# Preliminary and Final DRAINAGE PLAN AND REPORT

## **ROCKY TOP MOTEL AND CAMPGROUND**

County File No.: PPR2140

SUBJECT: Drainage Plan and Report  
Rocky Top Motel and Campground

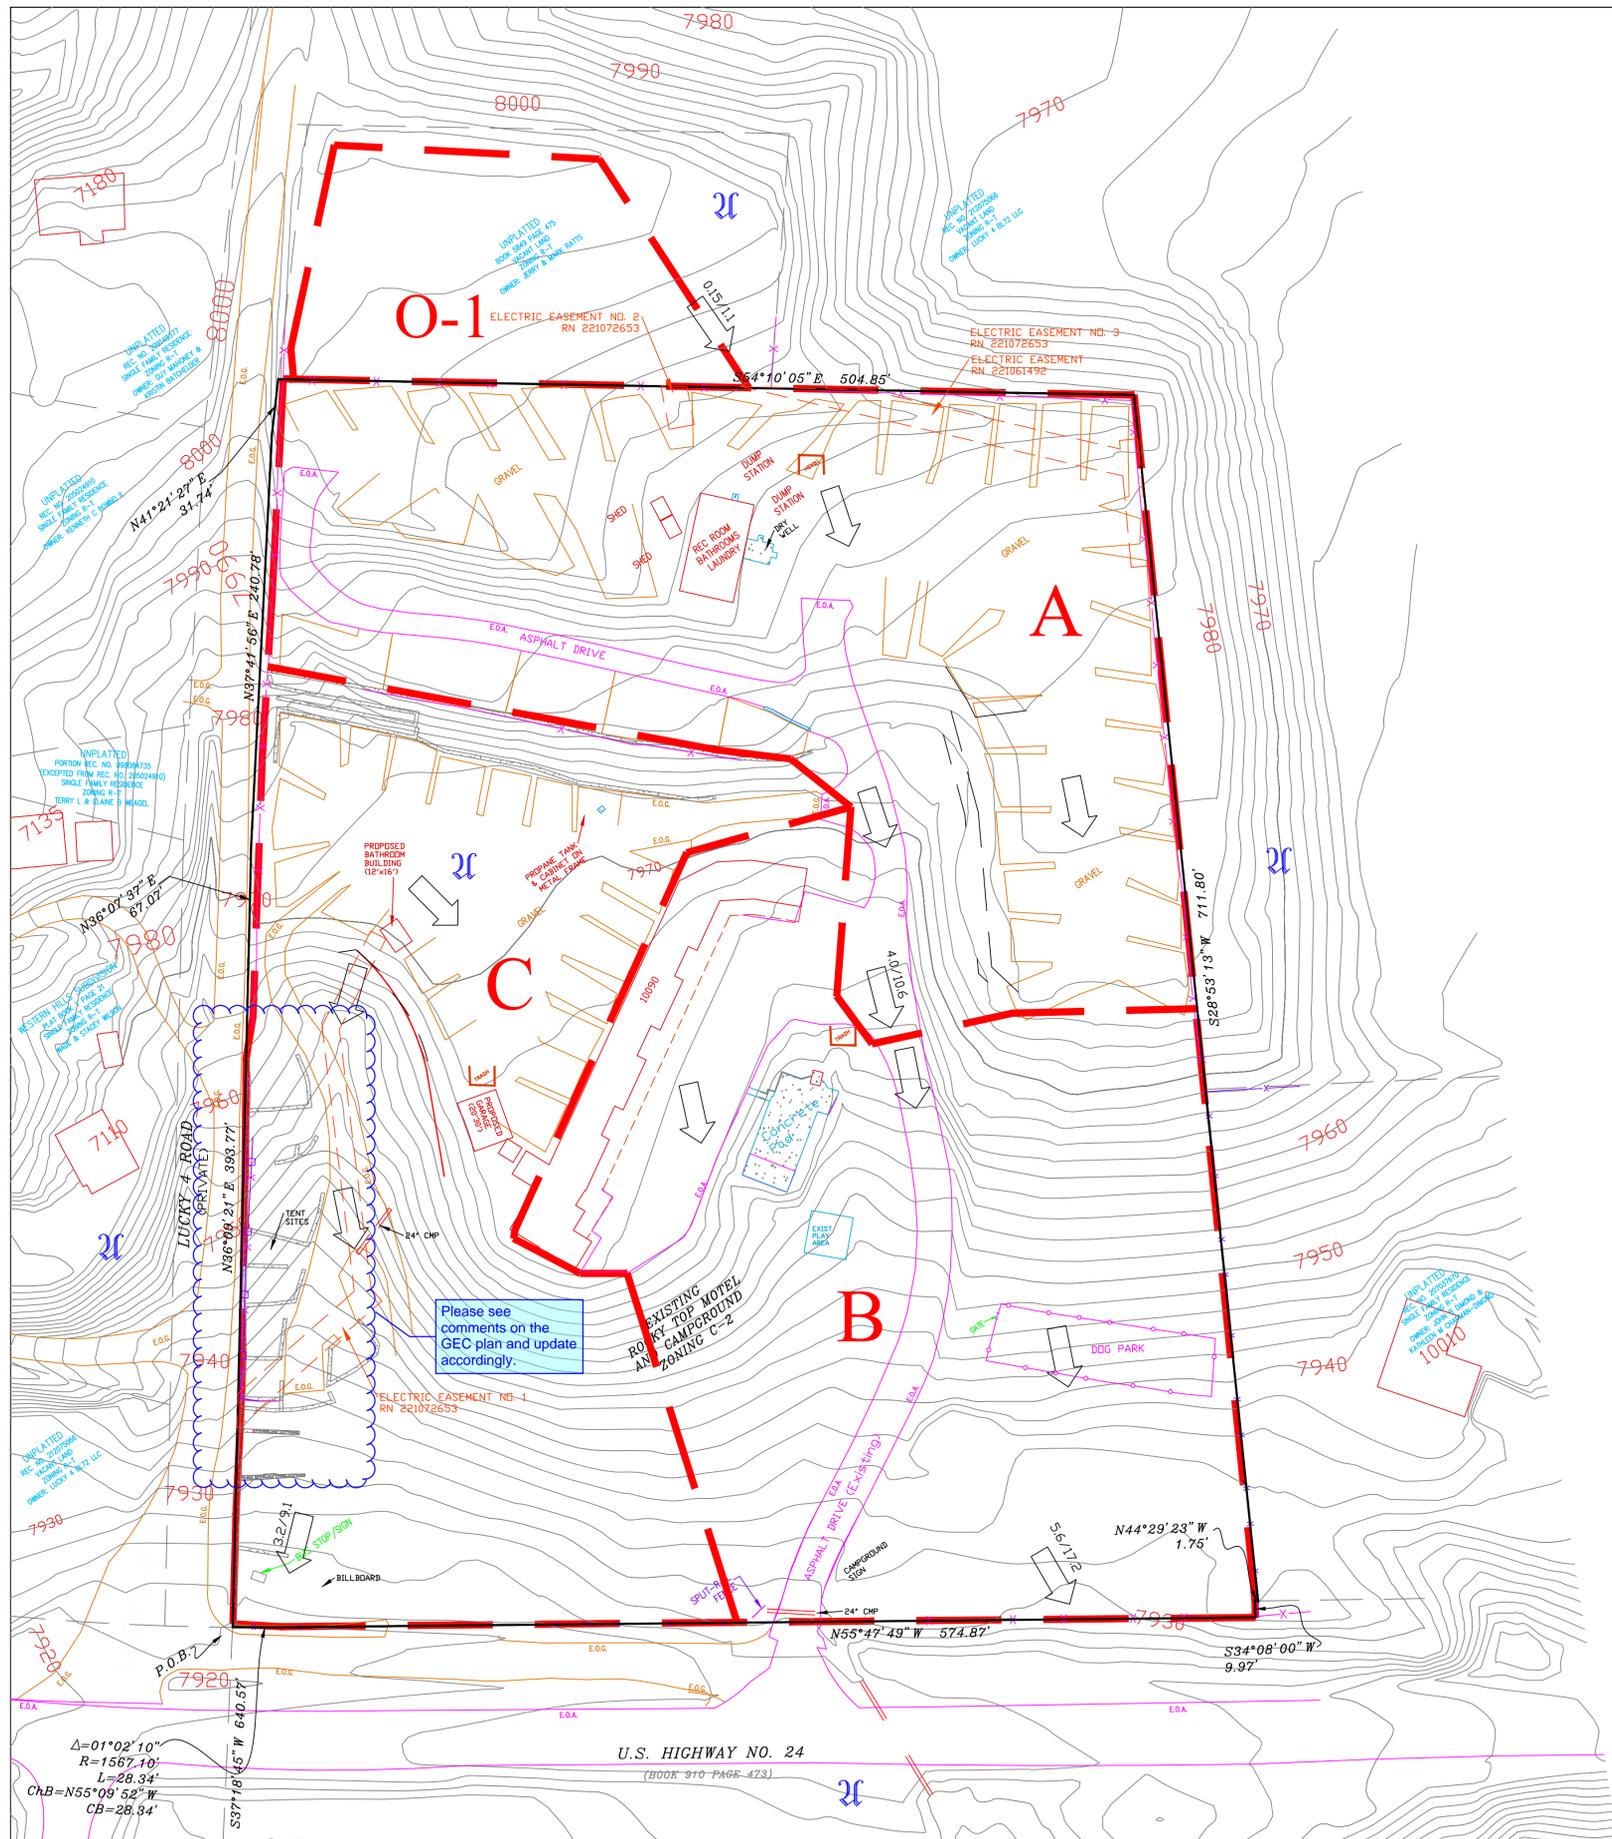
Please see comments in the narrative of the report and revise the drainage plan as necessary.
